B100796-AC – Clarendon Road

S96a Planning Changes Comparison

Basement

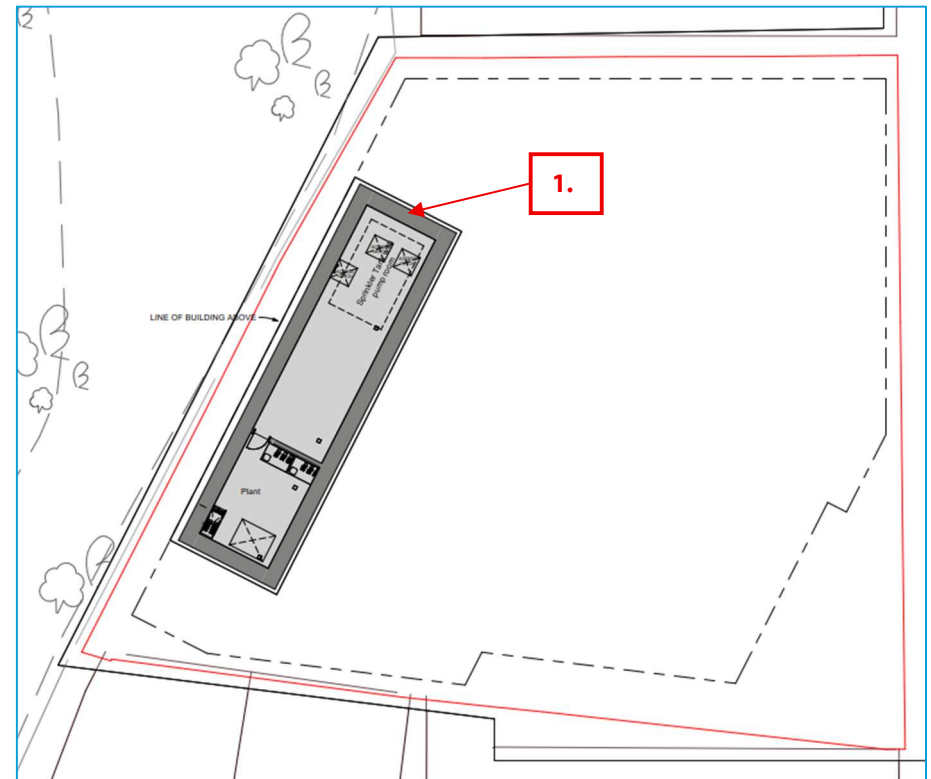
1. Basement footprint increased to accommodate required mechanical plant and sprinkler tank.

Ground Floor Layout

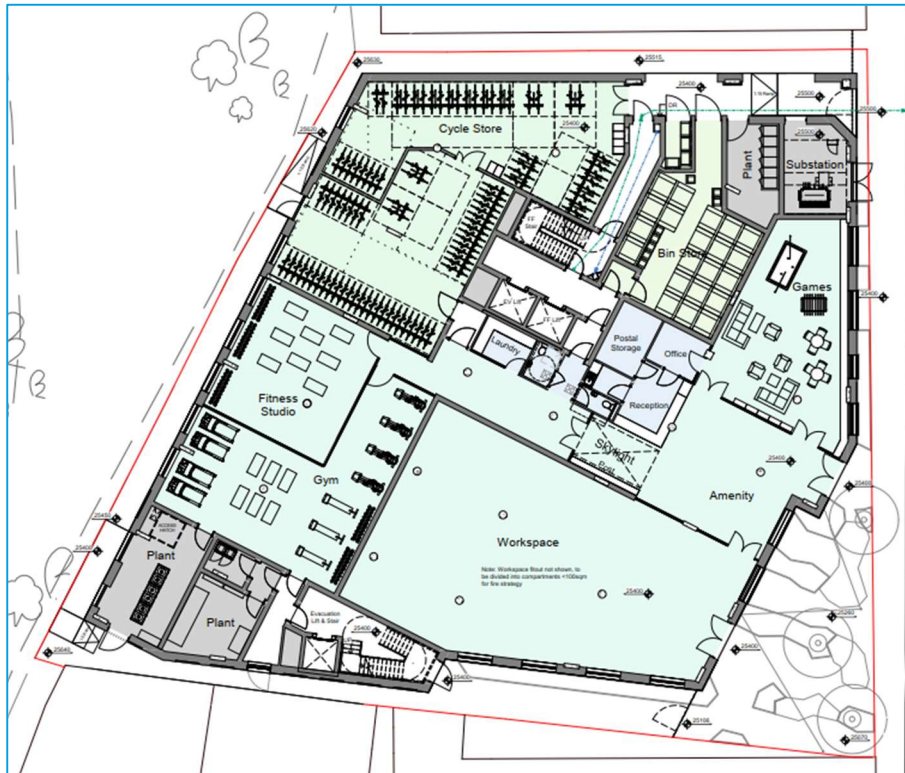
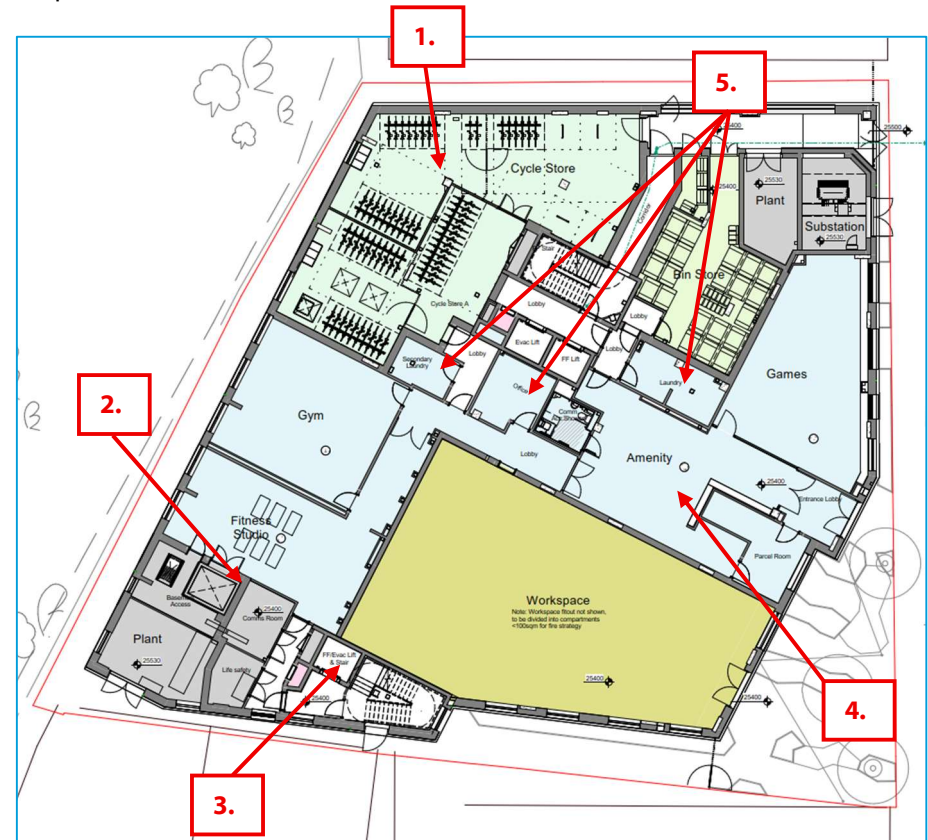
1. Cycle store segregated
2. Plant space to South of plan increased.
3. Fire Fighting core introduced to South stair core.
4. Entrance Foyer developed and reception desk removed.
5. Management office and laundry relocated, and additional laundry room added near cycle store

First floor layout

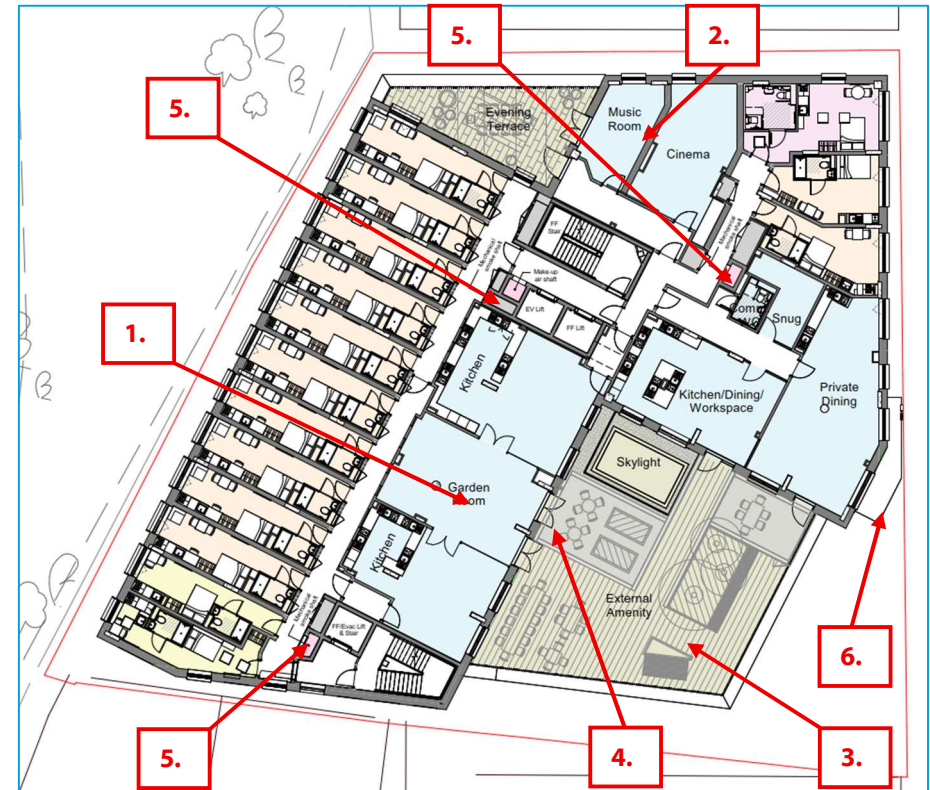
1. Garden room relocated to break up kitchen/dining spaces.
2. Music room added and cinema room reduced.
3. Terrace landscaping updated.
4. Additional door added to new garden room onto terrace.
5. Natural smoke ventilation shafts replaced with mechanical shafts.
6. Canopy outline updated.

All levels from 02 upwards

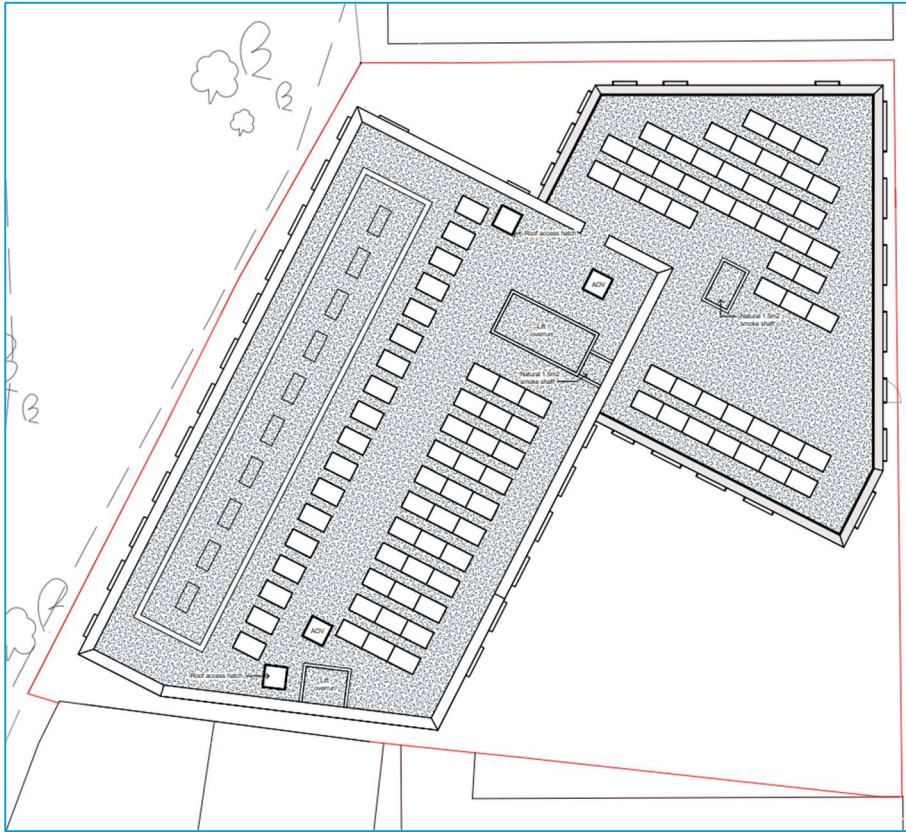
1. Premium studio next to Southern stair core swapped with large standard studio at the front of building.

Roof

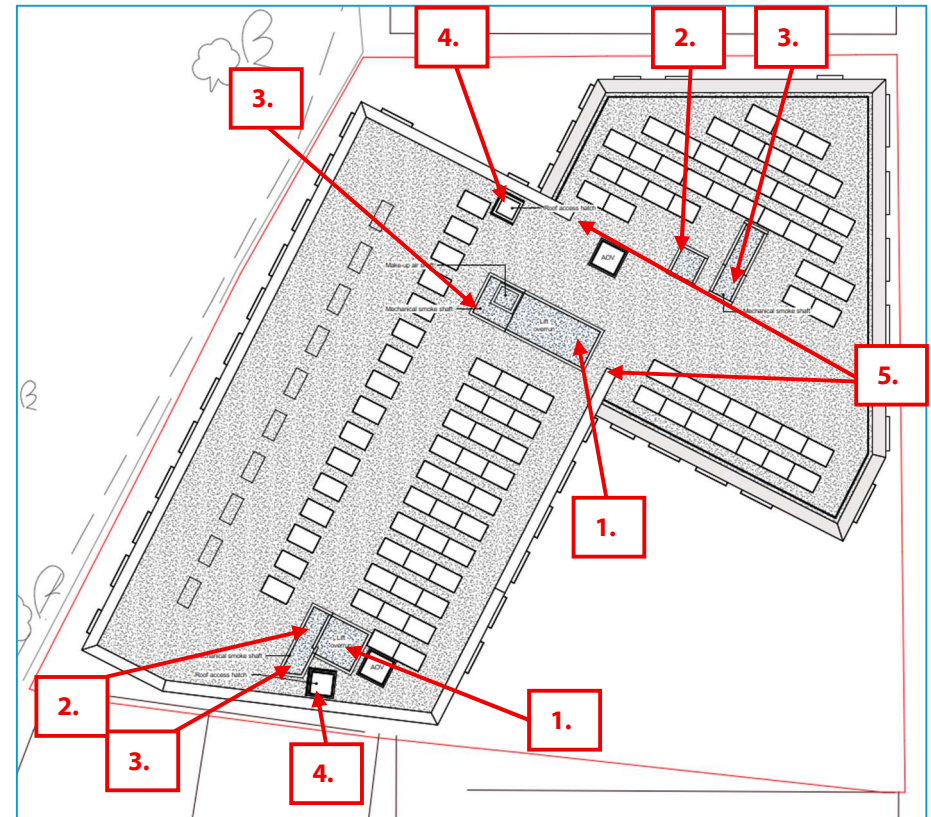
1. Lift overruns updated to coordinate with the lower levels.
2. Riser extensions added.
3. Mechanical smoke shafts added.
4. Roof access hatches and AOV's relocated.
5. Parapet extensions between blocks onto roof reduced

Elevations

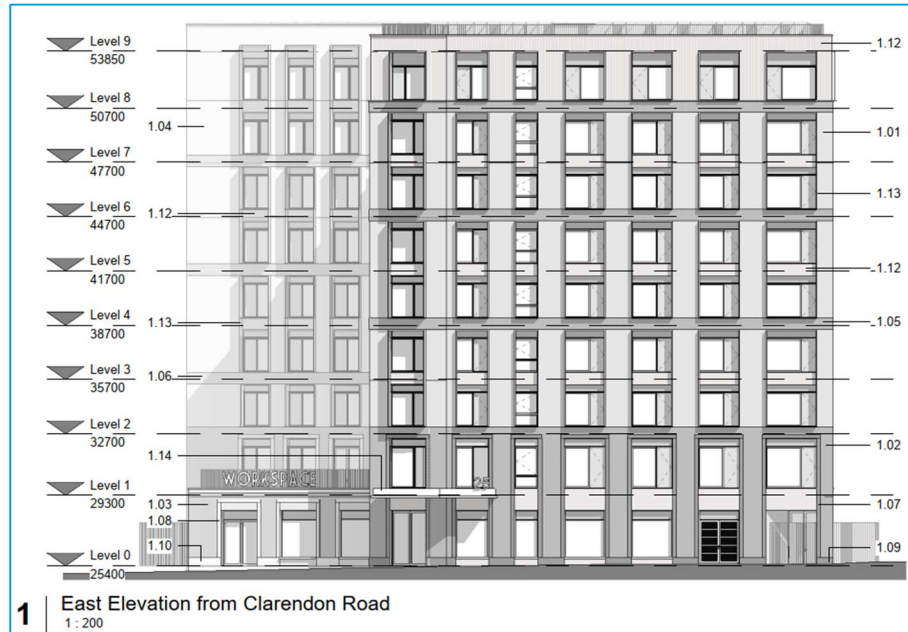
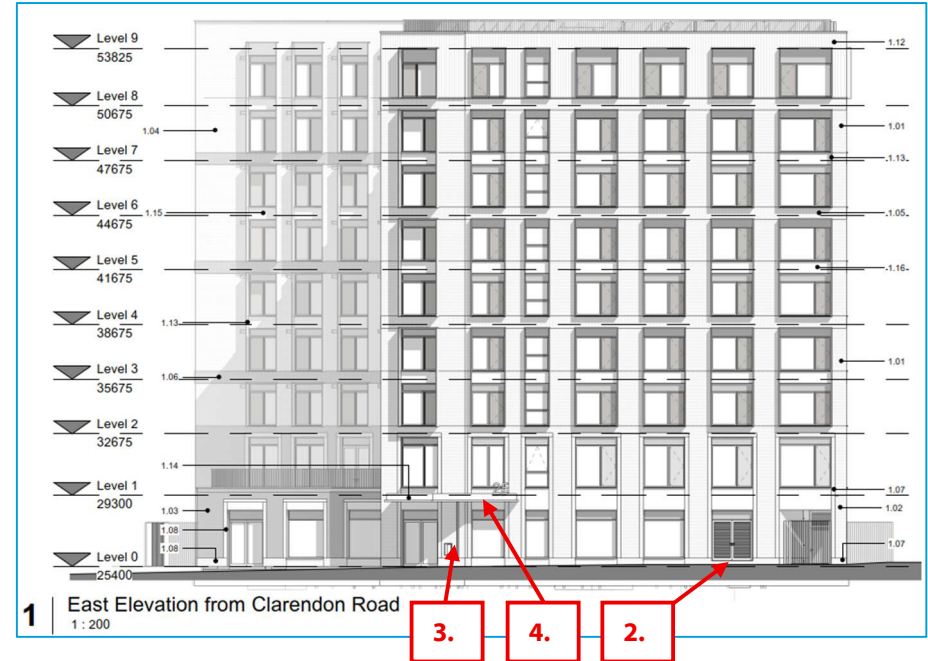
1. Minor adjustments to window positions.
2. Substation door threshold raised up in line with DNO requirements.
3. Dry-Riser inlet box added to entrance.
4. Canopy dropped marginally for construction interfacing with window above.

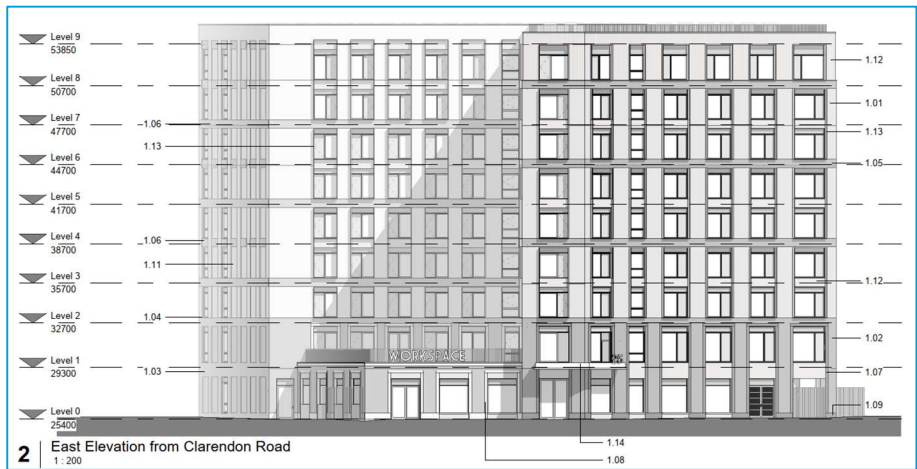
1. Dry-Riser inlet box added to side of Workspace.
2. Make up air AOV's added to Southern stair core.
3. Generator room double door added to facilitate installation and future replacement.
4. Additional louvre added to generator room.
5. Fire escape door to Southern core moved.
6. Recess to upper rainscreen cladding removed, as the corrugated cladding provides relief/texture to the wall.
7. Vent terminals added to walls for mechanical ventilation to studios.

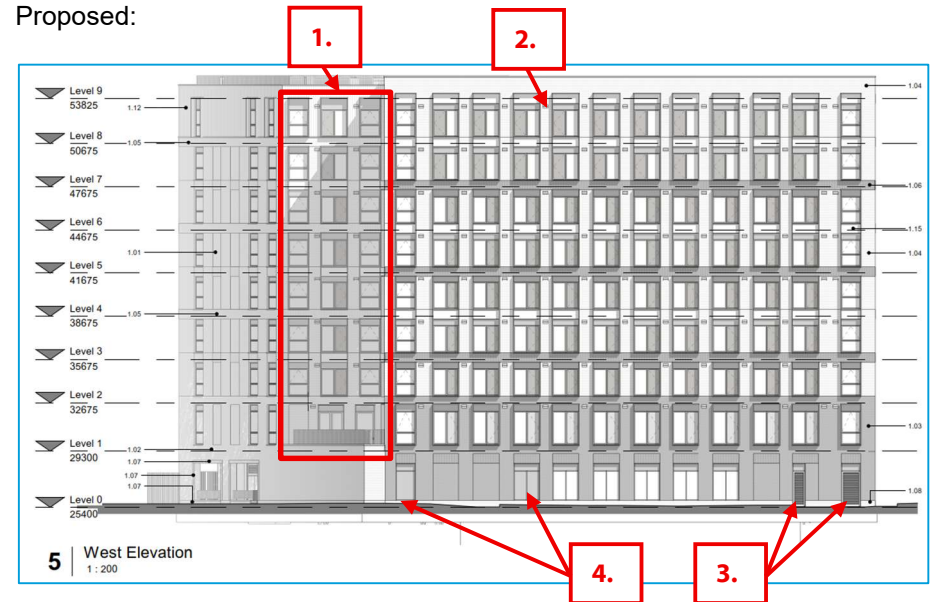
1. Window positions and sizing above evening terrace updated to coordinate with studio services requirements and re-entrant corner condition for fire safety compliance.
2. Vent terminals added to walls for mechanical ventilation to studios.
3. Louvre sizing to generator room adjusted.
4. Glazing to cycle stores made opaque.

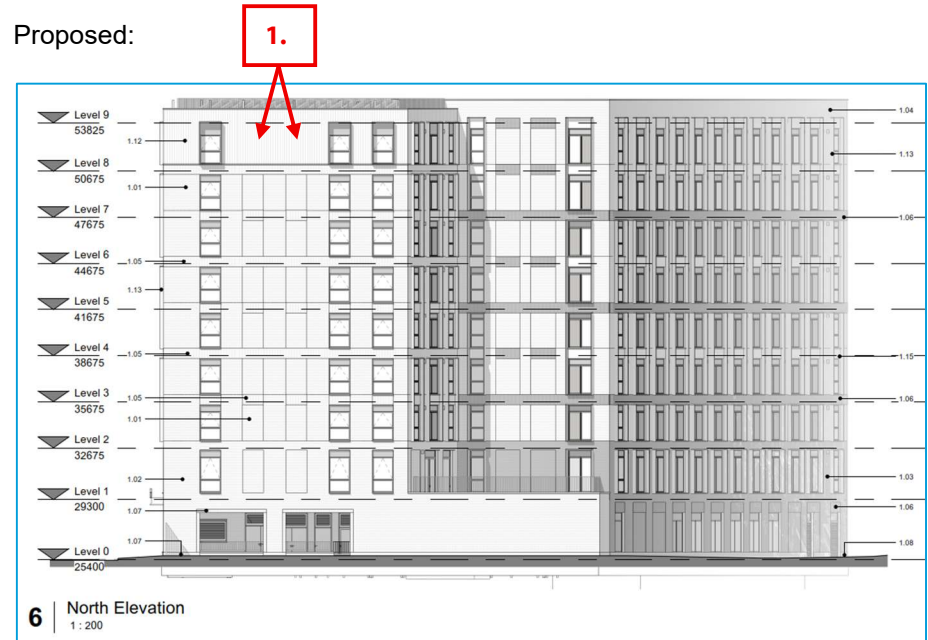
1. Recess to upper rainscreen cladding removed, as the corrugated cladding provides relief/texture to the wall.
